Date : January 19, 1962

Subject : Current Configurations of Pressure Suit and Parachute

FULL PRESSURE SUIT 1962
OXCART

- a) SAME RIG AS NO. 10.
- b) SAME SUSPENSION POINTS
- c) REMOVED NECK COLLAR

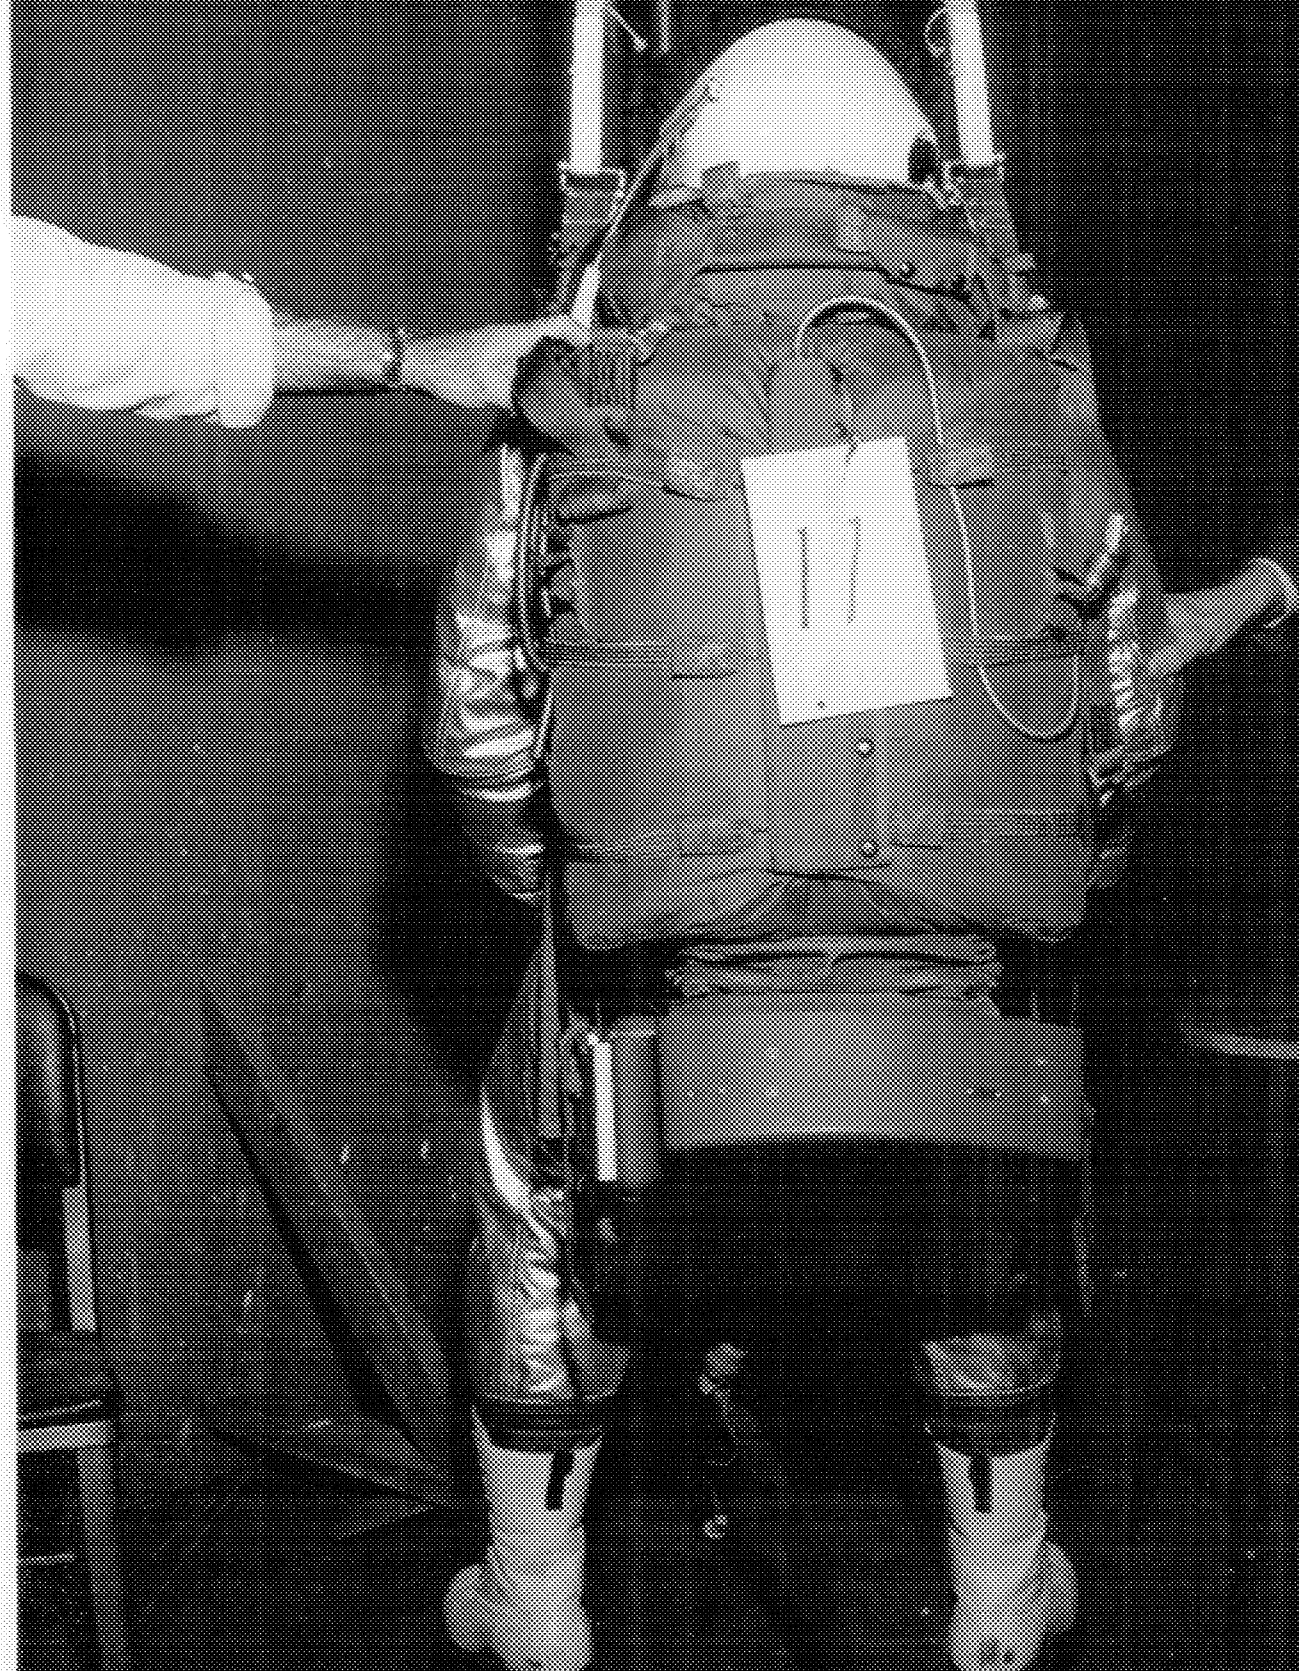
- a) [] CONSIDERS MOBILITY BETTER
WITH COLLAR REMOVED - EVEN BETTER
THAN OTHER RIG IN #9 & #8

- b) [] LIKES SUSPENSION BETTER
THAN #9

- c) [] CONSIDERS IT GOOD

STATINTL
12

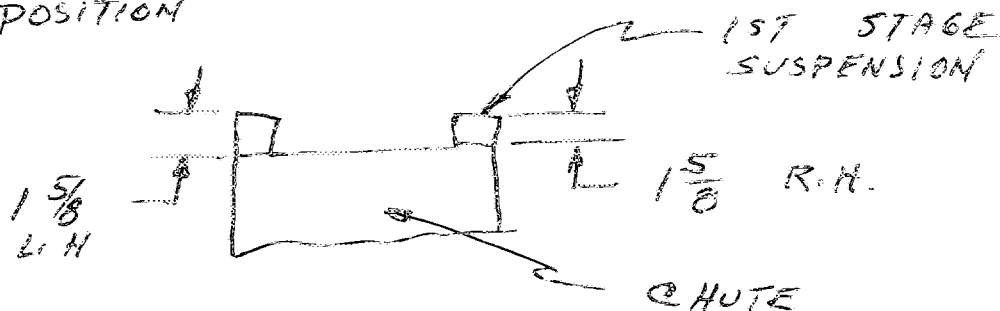
- a) CONSIDERS MORE COMFORTABLE IN CHEST
- b) MORE COMFORTABLE ALL AROUND

THIS IS RIG THAT WAS CONSIDERED
ACCEPTABLE AND REVISIONS ARE BEING MADE
TO THIS CONFIGURATION.
